D. Design Overlay Zone

3.12 Structure Height

4.0 View Preservation Regulations

Figure D-1: Structure Height controlled by Angle Planes on Coors Blvd.

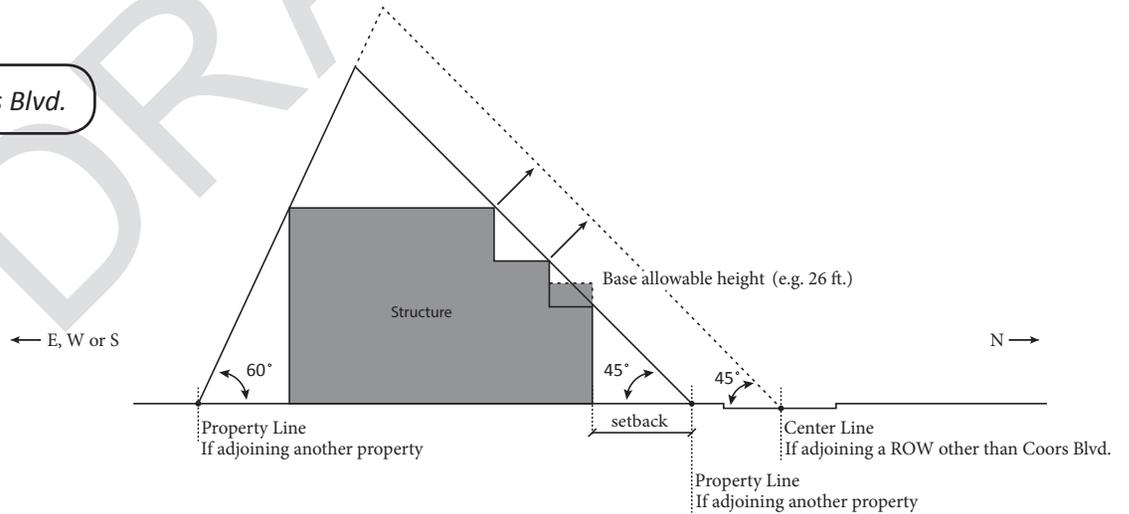
- i) Height of structures is determined from the finished grade of the site.
- ii) Maximum height shall be per the underlying zone with the following exceptions:
 - a. Structures in the View Preservation sub-area are subject to its height and mass regulations (see Section 4.3).
 - b. In zones where height is limited by an angle plane drawn from the centerline of an adjacent public right-of-way, the following applies to structures on properties that adjoin the Coors Blvd. ROW (or adjoin the landscape setback/buffer at the Coors Blvd. ROW) and are located outside designated Community or Major Activity Centers: the 45° or 60° angle plane on Coors Blvd. shall be drawn from the property line (using the full ROW width recommended in this Plan, see Figure D-1) rather than the centerline of Coors Blvd. The intent is to maintain visual open-ness

REVISED

NEW: Sight Lines on Sites < 5 acres

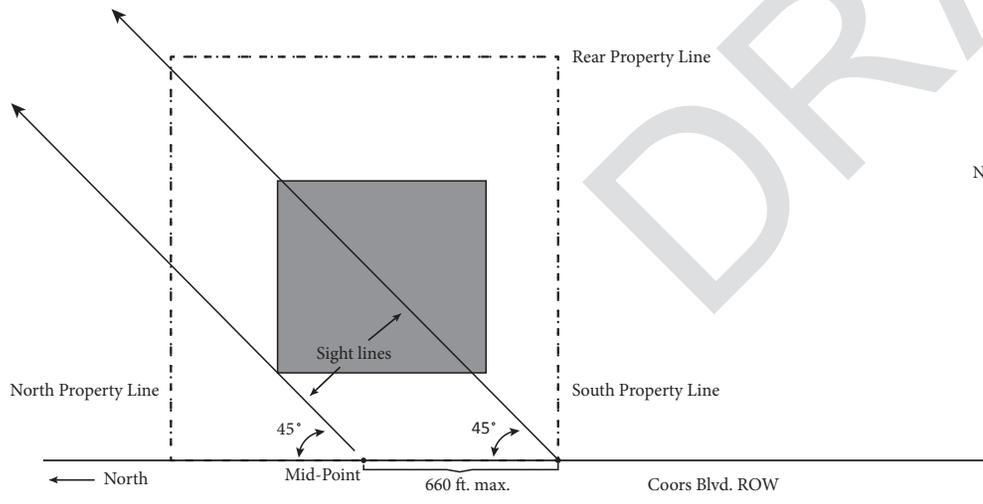
a. Development sites of less than 5 acres *- the point at the southwest corner of the site; and at the mid-point of the property line along Coors Blvd. or at a distance of 660 ft. from the southwest corner, whichever distance is less.

NEW: Sight Lines on Sites ≥ 5 acres

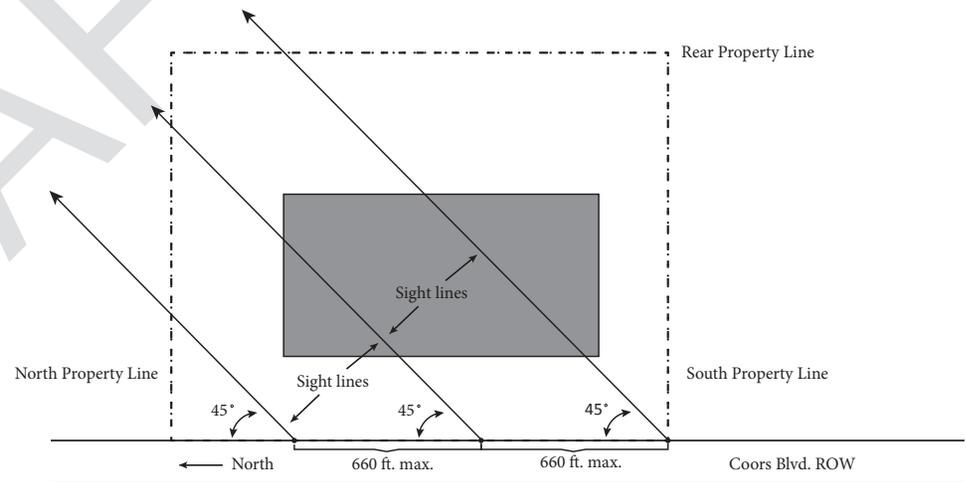
- b. Sites of 5 acres or greater *- the point at the southwest corner of the site; and points at 660 ft intervals along the property line, up to the northwest corner of the site.
- ~~Sight lines shall be added as necessary to incorporate all proposed structures on the site or to show the area between setbacks if the location of structures has not been determined e.g. in a site development plan for subdivision.~~

~~The direction of the sight lines follows a horizontal 45° angle from the alignment of Coors Blvd., i.e. in approximately a northeasterly direction.~~

Figure D-3: View Frames and Sight Lines and View Area for a Site off Coors Blvd. - Plan View

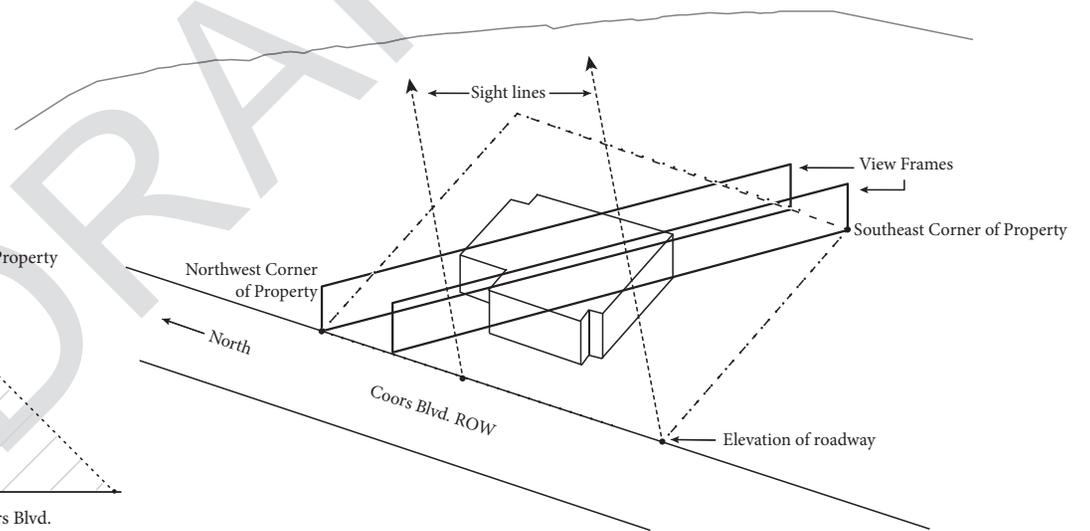
*Note: For sites that are separated from the Coors Blvd. ROW by a platted strip of land forming the landscape setback or that are located further east, the sight lines of the view frames begin at points on Coors Blvd. that correspond to the southwest corner, mid-point etc. as drawn at a 90° angle from the nearest property line of the site to the Coors Blvd. ROW. (See Figure Xref.)

REVISED

Figure D-4: View Frames and View Area with Structures (Site Development for Building Permit) – Plan View

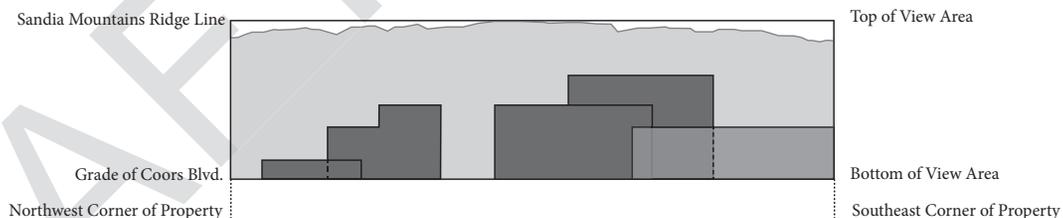
iii) View Area. The view area consists of two or more view frames for each site, depending on the size and shape of the site. The view area must encompass the entire horizontal expanse of the site, i.e. from the northwest to the southeast corners. Two situations are shown in the following diagrams: 1) a development proposal where the footprint and size of the buildings are identified, such as in a site development plan for building permit; 2) a development proposal that sets the buildable area of the site and the potential size of future buildings, such as in a site development plan for subdivision. ~~The bottom of the~~

REVISED

Figure D-6: View Frames and View Area for Buildable Area – Plan View

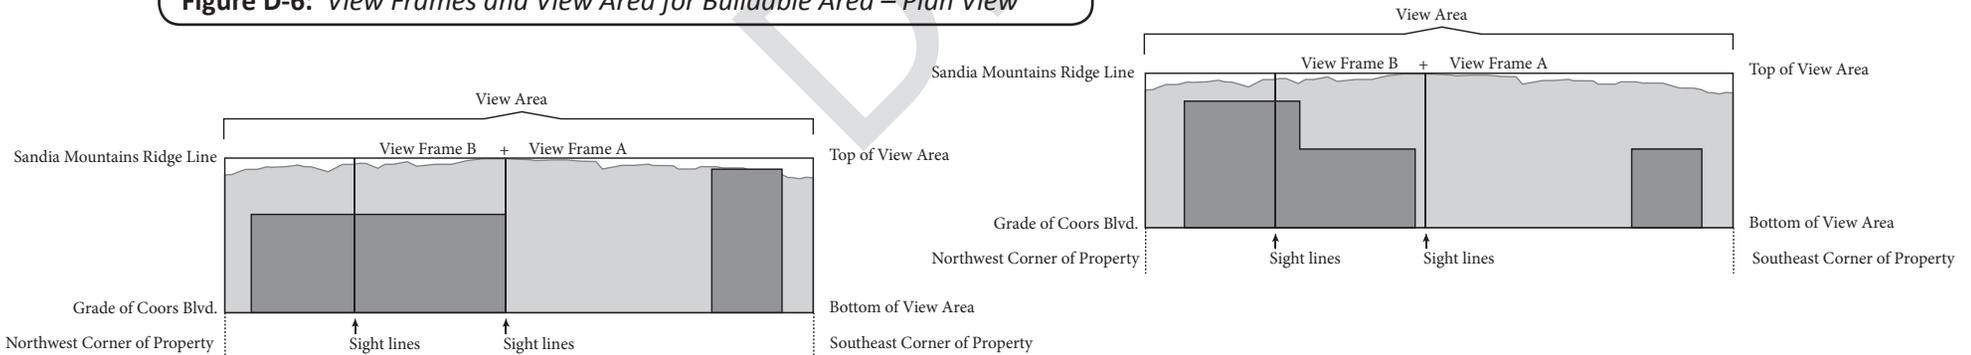
REVISED

NEW: Horizontal View Plane

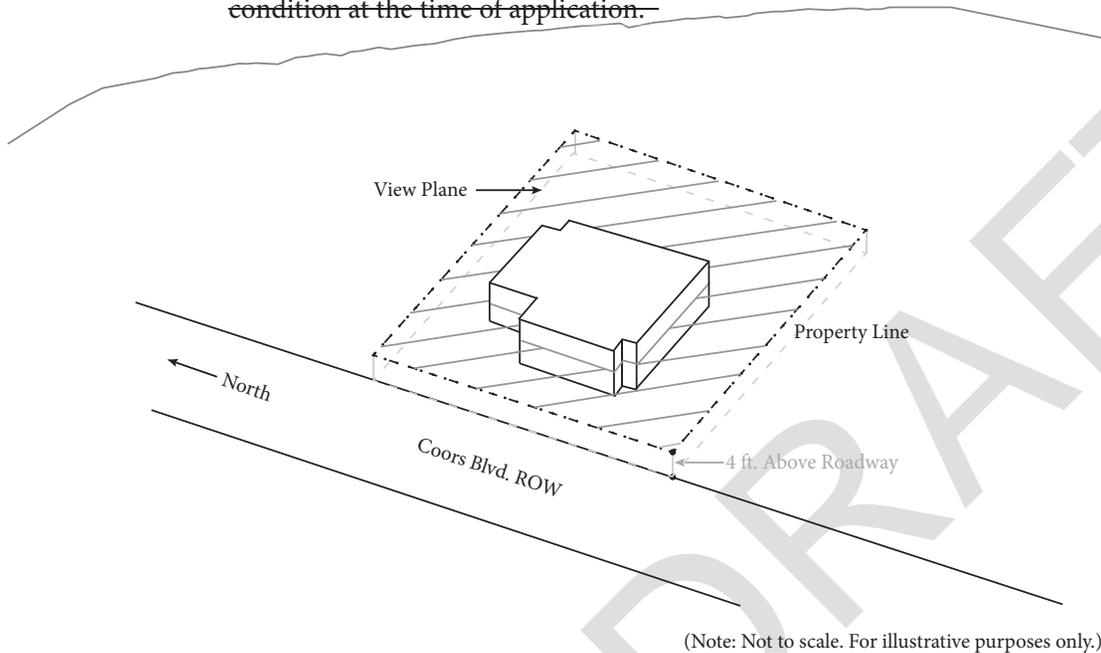
- iv) *Horizontal View Plane.* A horizontal plane established at 4 ft. above the east edge of the existing pavement of Coors Blvd. ~~i.e. at the time of application~~ that begins at the edge of the Coors ROW and that extends across the site to its eastern boundary. The grade of the pavement reflects the existing condition at the time of application.

NEW: Structure Mass

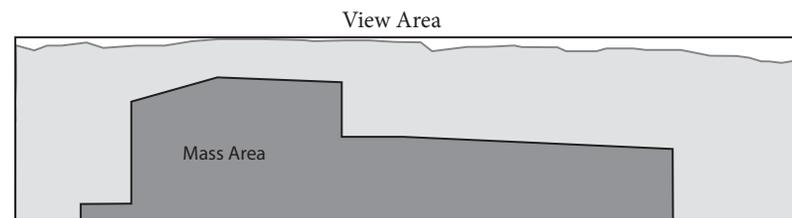
- v) Mass. The mass or bulk of the structure(s) on a site that is visible within the view area. This visual mass is measured as an area in proportion to the total view area.

Figure D-8: View Windows - Two Concepts

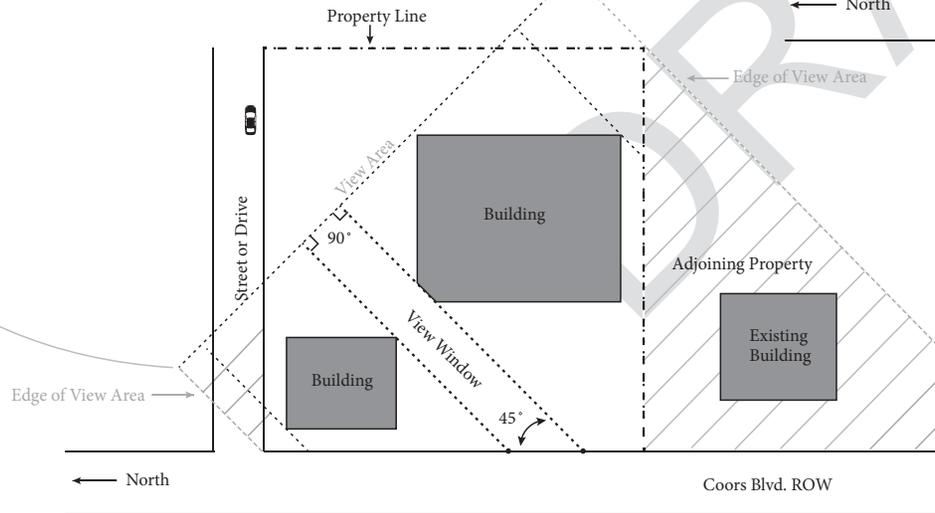
vi) View Window. Consists of a vertical portion of a view area that provides an unobstructed view of the Sandia Mountains, and provides a view of the bosque to the extent possible. The direction of a view window may be at an angle between 45° and 90° (inclusive) from the alignment of Coors Blvd. View windows apply only to properties north of Paseo del Norte.

REVISED

Figure D-10: Structure Mass in VP sub-area

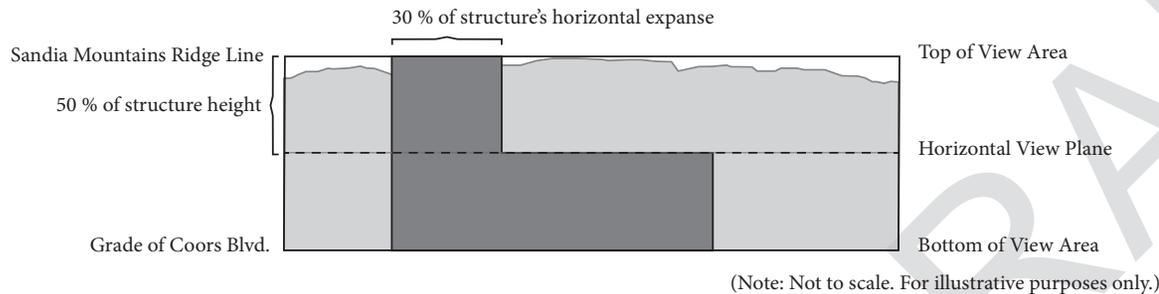
1. No more than 30% of an individual structure's ~~width~~ horizontal expanse, as seen in the view area, shall penetrate above the horizontal view plane ~~as seen in the view area. This only applies to structures greater than the base allowable height of 16 ft (residential) or 20 ft. (commercial).~~
2. The visual mass of All the structure(s) on the development site shall obscure no more than 50% of the view area.

REVISED & MOVED
